Access Compliance Report Public Rights-of-Way (Curb Ramps)

Main Street: CAMERON_LN Cross Street: VANDERLIP_AVE Location: SW

ADA ID: RPAT211006104745 Ramp Type: Type 1 - Perpendicular Diagonal Initial Pass/Fail: Fail Overall Compliance: No Severity Score: 15

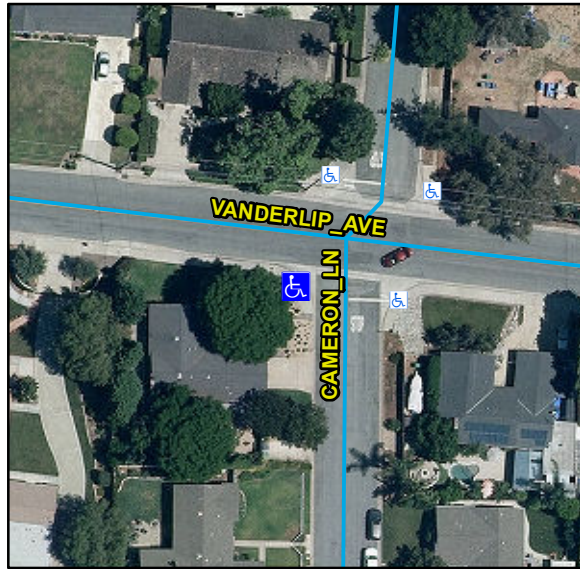
Compliance	Description	Data	Compliance	Description	Data
N/A	Ramp Length (in)	47	N/A	Flare Type LT	
Yes	Ramp Width (in)	50			N/A
No	Ramp Run Slope (%)	8.5	N/A	Flare Slope LT (%)	N/A
Yes	Ramp Cross Slope (%)	0.6	N/A	Flare Traversable LT	N/A
N/A	Landing Present	N/A	N/A	Flare Type RT	
N/A	Landing Length (in)	N/A			N/A
N/A	Landing Width (in)	N/A	N/A	Flare Slope RT (%)	N/A
N/A	Landing Run Slope (%)	N/A	N/A	Flare Traversable RT	N/A
N/A	Landing Cross Slope (%)	N/A	N/A	DWS Provided	N/A
N/A	Landing Movement Obstructed?	N/A	N/A	DWS Contrast	N/A
	Landing Movement Type	N/A	N/A	DWS Length (in)	N/A
N/A	Landing Shared	N/A	N/A	DWS Full Width	N/A
N/A	Clear Space	Yes	N/A	DWS Offset Left (in)	N/A
N/A	Clear Space To Crosswalk (in)	N/A	N/A	DWS Offset Right (in)	N/A
N/A	Marked Crosswalk 1	No	N/A	Marked Crosswalk 2	No
	Crossing 1 Direction	E		Crossing 2 Direction	N
	Marked Crosswalk 1 Width (in)	N/A		Marked Crosswalk 2 Width (in)	N/A

Remove & Replace Curb Ramp With Two New Directional Ramps or Equivalent.
